# **Metropolitan Parks and Open Space Commission Report**

Subject: Luce Line Regional Trail Master Plan, Minneapolis Park and Recreation Board

**Subject**: Luce Line Regional Trail Master Plan, Minneapolis Park and Recreation Board, Review File No. 50120-1

Figure 5: Proposed Plan: Luce Line Regional Trail

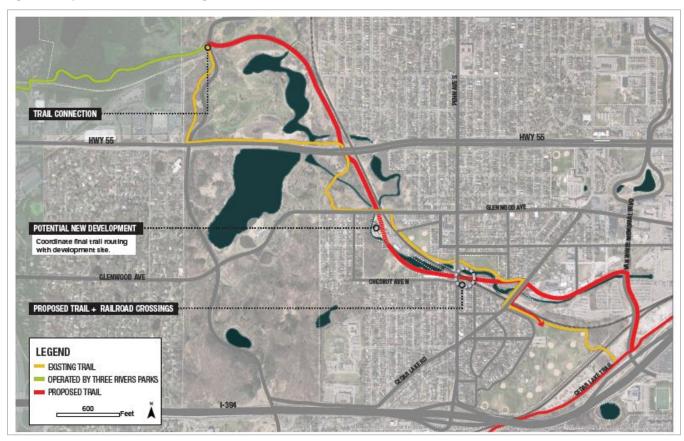
<u>Transportation Planning</u> (Russ Owen 651-602-1724) – The master plan should acknowledge that trail Segments 1, 2, and 3 that follow the CP Rail line are included on the Regional Bicycle Transportation Network as a Tier 2 alignment. This designation in the *Transportation Policy Plan* includes this as a regional priority for investment via regional transportation funds.
